star bulletin

Date: March 26, 2015
Order No.: S-B-27.30/127
Group: 27

**SUBJECT: MY-All, Models with Transmission 722.9 (all serial numbers: 05552226, 07814299, 10141478 and forward)
Transmission Seal Change**

Figure 1.

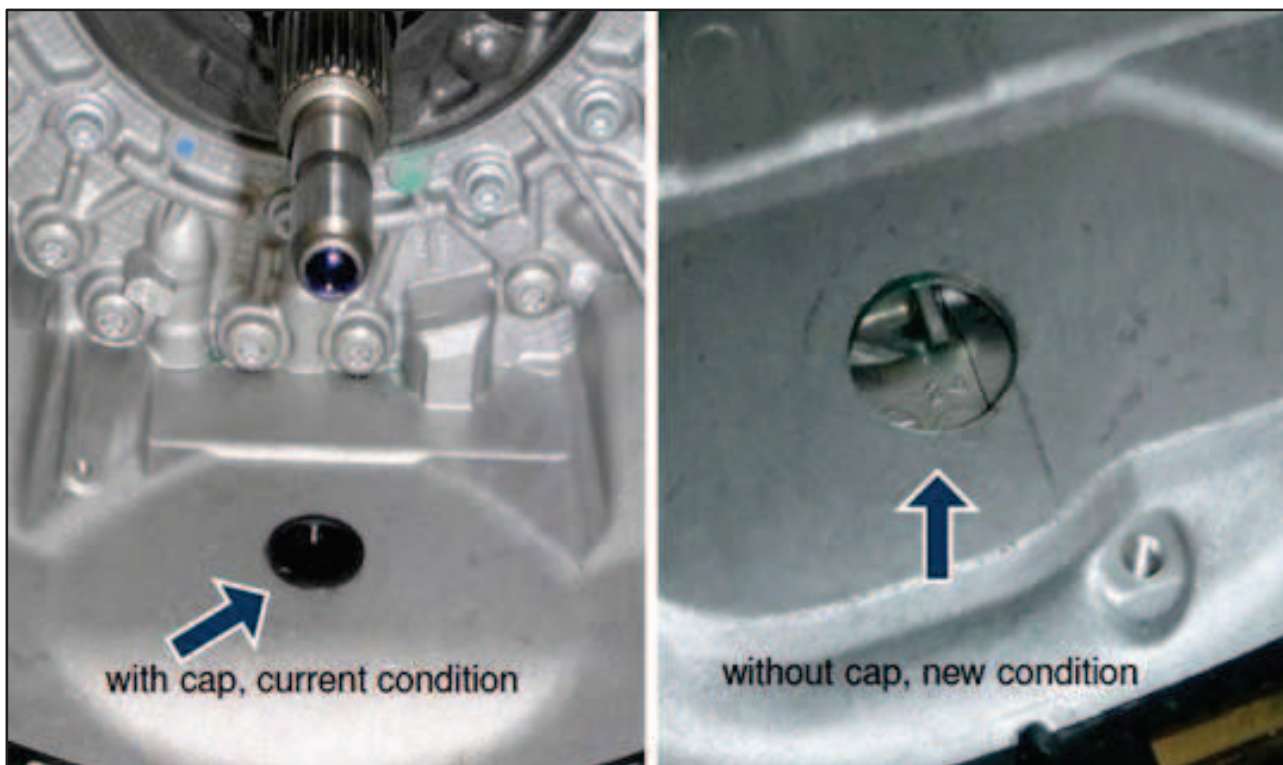
Due to improved noise, vibration and harshness (NVH) behavior of the torque converter, elastomer sealing (Part number A 222 271 00 80) on the bell housing (Figure 1) is no longer necessary. Any 722.9 transmission variants being produced will have the seal removed. New vehicles may arrive with or without the seal. No replacement is necessary for vehicles arriving without a seal.
